# SERVICE BULLETIN

## ENGINE – TURBINE EXHAUST CASE ASSEMBLY – PROVIDE HEATSHIELDS FOR THE NO.5 BEARING TUBE ELBOWS – CATEGORY CODE 5 – MOD.ENG-72-0104

# V2500-ENG-72-0104

Prepare the Oil Tubes for the Insulation Shielding Assembly  
Fig.1

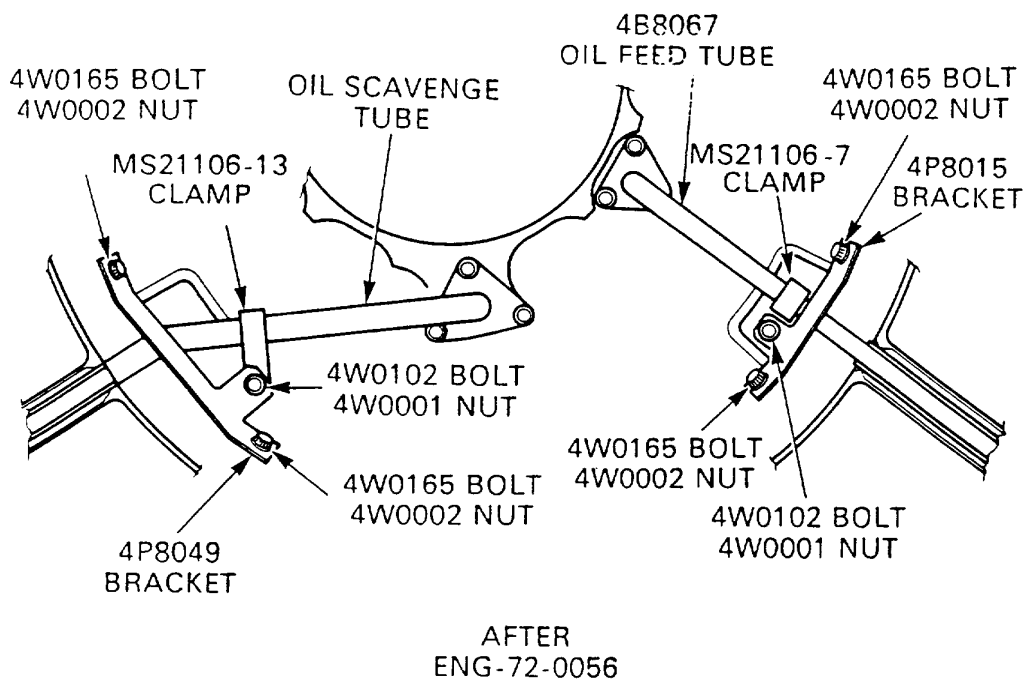
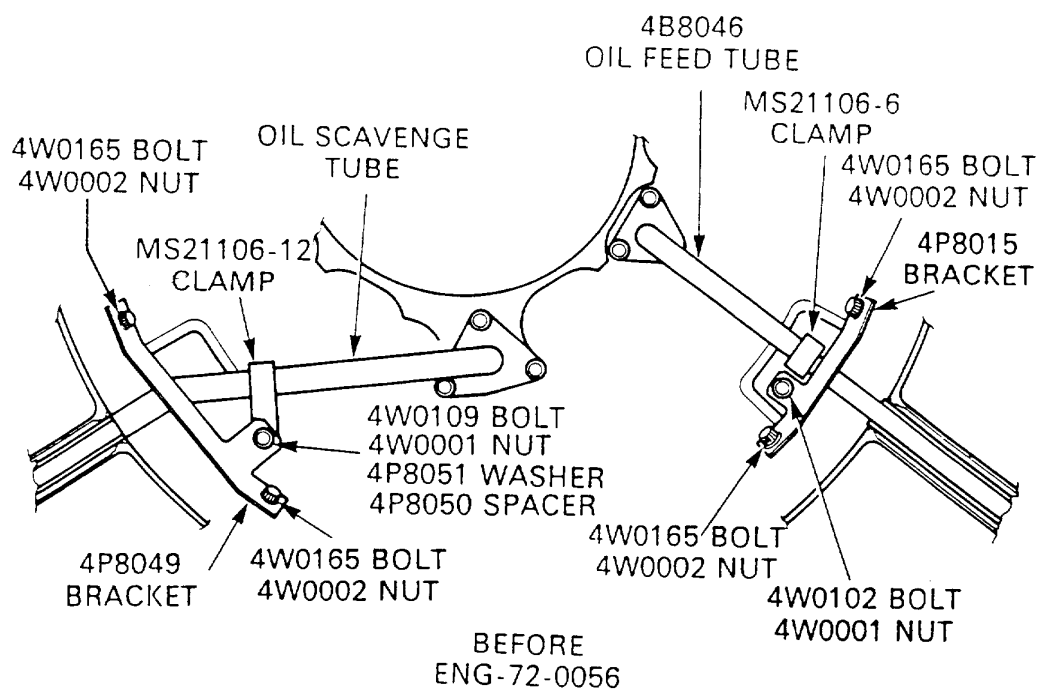
### B. Removal Instructions for Engines Not Incorporating Service Bulletin V2500-ENG-72-0056. See Figure 1.

- (1) Identify the Oil feed Tube
- (2) Remove the Nut and Bolt which hold the PN MS21106-6 Clamp, to the PN 4P8015 Bracket.
- (3) Remove the Bolts and Nuts which attach the PN 4P8015 bracket, to the Inner Support of the Case.
- (4) Remove and discard the PN 4P8015 bracket. Retain Bolts and Nuts.
- (5) Remove and discard the PN MS21106-6 Clamp, from the Oil Feed Tube.
- (6) Identify the Oil Scavenge Tube.
- (7) Remove the Nut, the Bolt, the Washer and the two Spacers which hold the PN MS21106-12 Clamp, to the PN 4P8049 Bracket.
- (8) Discard the PN 4W0109 Bolt the PN 4P8051 Washer and the two PN 4P8050 Spacers. Retain the PN 4W0001 Nut.
- (9) Remove the Bolts and Nuts which attach the PN 4P8049 Bracket, to the Inner Support of the Case.
- (10) Remove and discard the PN 4P8049 bracket .Retain Bolts and Nuts.
- (11) Remove and discard the PN Ms21106-12 Clamp, from the Oil Scavenge Tube.

### C. Removal Instructions for Engines Incorporating Service Bulletin V2500-ENG 72-0056. See Figure 1.

- (1) Identify the Oil Feed Tube
- (2) Remove the Nut and Bolt which hold the PN Ms2106-7 Clamp, to the PN 4P8015 Bracket.
- (3) Remove the Bolts and Nuts which attach the PN 4P8015 Bracket, to the Inner Support of the Case.
- (4) Remove and discard the PN 4P80156 Bracket. Retain Bolts and Nuts.
- (5) Remove and discard the PN Ms21106-7 Clamp, from the Oil Feed Tube.

- (6) Identify the Oil Scavenge Tube.
- (7) Remove the Nut and Bolt which hold the PN MS21106-13 Clamp, to the PN 4P8049 Bracket.
- (8) Remove the Bolts and Nuts which attach the PN 4P8049 bracket, to the Inner Support of the Case.
- (9) Remove and discard the PN 4P8049 Bracket . Retain Nuts and Bolts.
- (10) Remove and discard the PN Ms21106-13 Clamp, from the Oil Scavenge Tube. Retain the Bolt and the Nut.

Assembly of Insulation Shielding  
Fig.2

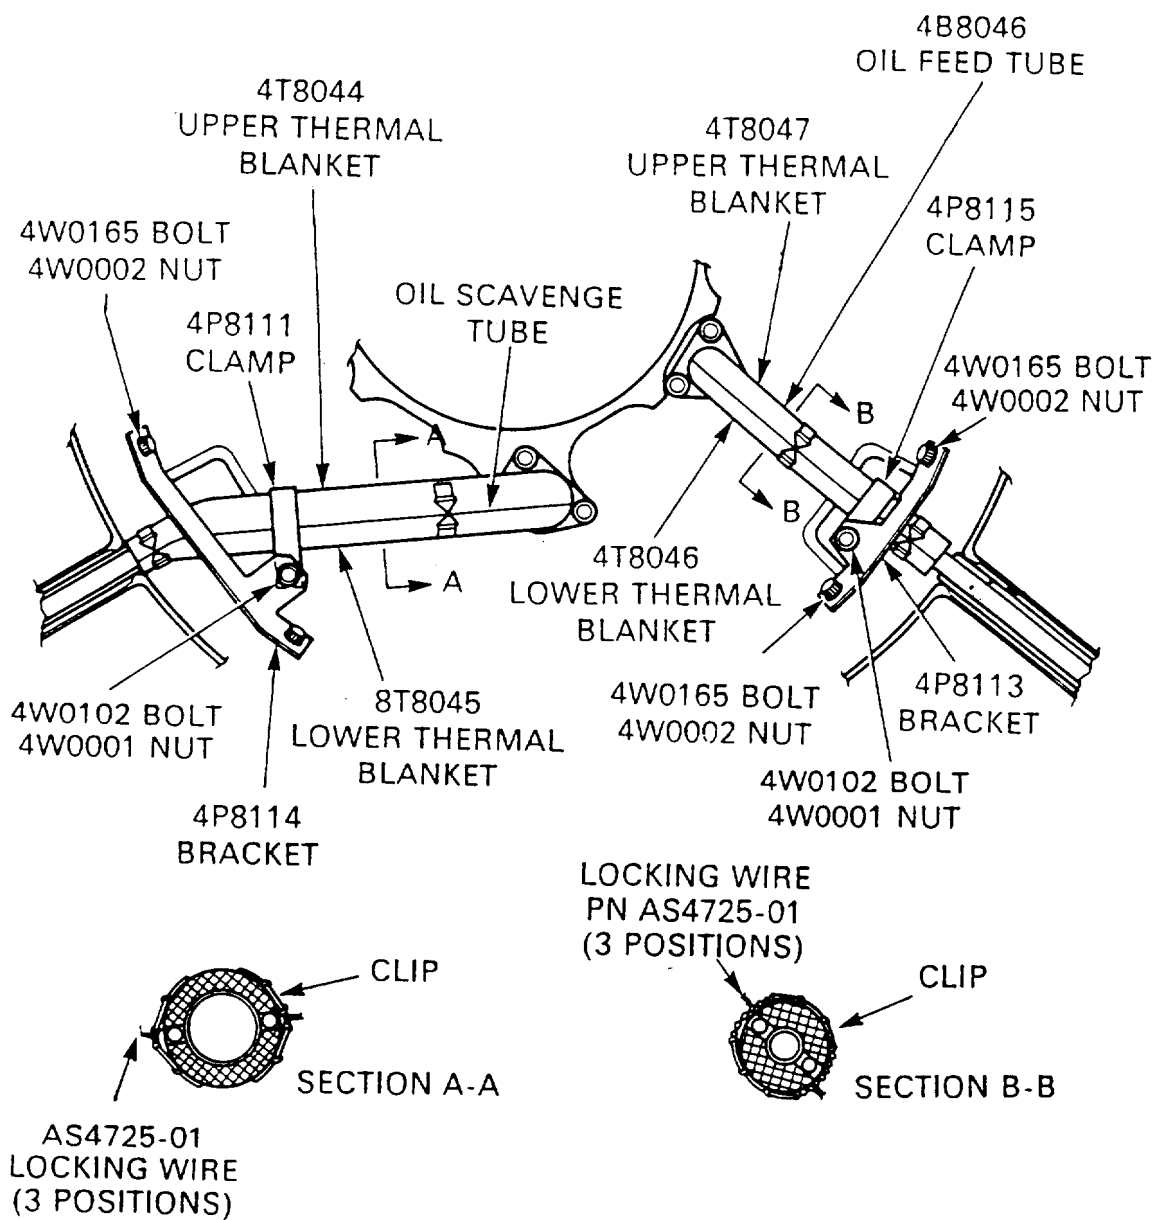
- (1) To avoid oil coking in oil feed and scavenge tubes, heat shields have been provided for the oil tubes elbows. In addition 2 new brackets and 1 clamp has been provided to the present configuration.
- (2) Incorporation of this service bulletin can be subsequent to the service bulletin V2500-ENG-72-0056. In such case the use of the oil tubes featuring the antiwear sleeves is permissible

## D. Assembly Instructions. See Figure 2

- (1) Install new PN 4T8046 Lower Thermal Blanket, and new PN 4T8047 Upper Thermal Blanket, on the PN 4B8046 or PN 4B8067 Oil Feed Tube.
- NOTE: It is permissible the use of superseded PN 4B8067 Oil Feed Tube, featuring the antiwear sleeves.

- (2) Safe the Clips (at 3 positions) on the Thermal Blankets with locking wire.
  - (3) Install new PN 4P8115 Clamp, on the Oil Feed Tube.
  - (4) Attach new PN 4P8113 Bracket, to the Inner Support of the Case with old Nuts and Bolts.

- (5) Torque the Bolts to 101.784 lbfin. (11,4 Nm). See in Reference (2), Chapter/Section 70-41-00 Torque Tightening Technique.
  - (6) Attach the PN 4P8115 Clamp, to the PN 4P8113 Bracket, with the old Nut and Bolt.

- (7) Torque the Bolt to the 17.701 lbfin. (2,0 Nm). See in Reference (2), Chapter/Section 70-41-00 Torque Tightening Technique.
  - (8) Install new PN 4T8044 Lower Thermal Blanket, and new PN 4T8045 Upper Thermal Blanket, on the Oil Scavenge Tube.

- (9) Safe the Clips (at 3 positions) on the Thermal Blankets with CoMat 02-138 locking wire.
  - (10) Install new PN 4P8111 Clamp, on the Oil Scavenge Tube.

- (11) Attach new PN 4P8114 bracket, to the Inner Support of the Case with old Nuts and Bolts.

- (12) Torque the Bolts to 101.784 lbfin. (11,4 Nm). See in Reference (2), Chapter/Section 70-41-00 Torque Tightening Technique.
- (13) Attach the PN 4P8111 Clamp to the PN 4P8114 bracket with the PN 4W0102 Bolt and PN 4W0001 Nut
- (14) Torque the Bolt to the 39.828 lbfin. (4,5 m). See in Reference (2), Chapter/Section 70-41-00 Torque Tightening Technique.
